WATER OAK APARTMENTS

**12,125 S IH 35, AUSTIN,
TX 78747
SP-2019-0109C**

VARIANCE REQUEST

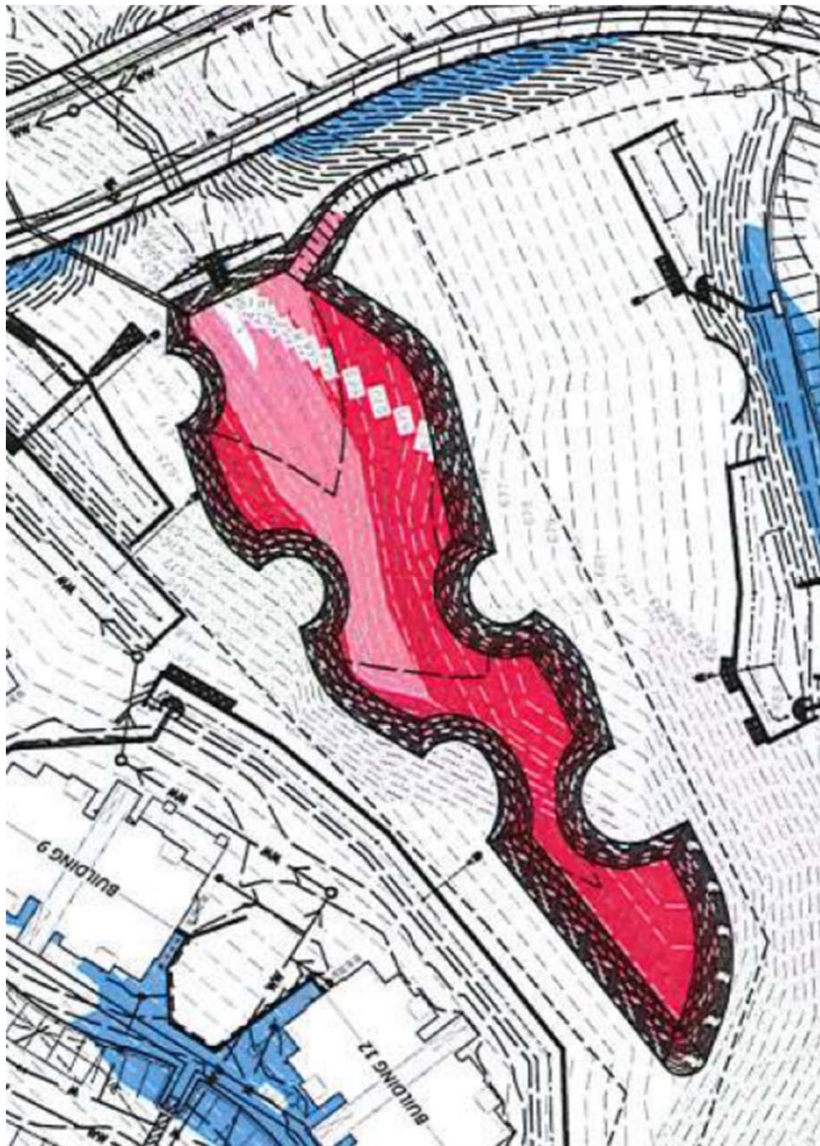
- Steep, wooded valley bisects site.

- Cut over 8 feet is restricted to ponds.

- Slopes in main pond are between 15 and 35 percent.
- Pond is designed to preserve Heritage trees. (See notches.)

Request to vary from LDC 25-8-341 to allow cut in excess of 4 feet on slopes exceeding 15 percent.

Staff recommends this variance with the following conditions:

- Stockpile and reserve topsoil for use in revegetation of disturbed areas.
- Revegetate disturbed areas adjacent to creek and pond with riparian plantings per 609S.6.
- Use enhanced erosion & sedimentation controls during construction to prevent outflow of sediment-laden water from pond.
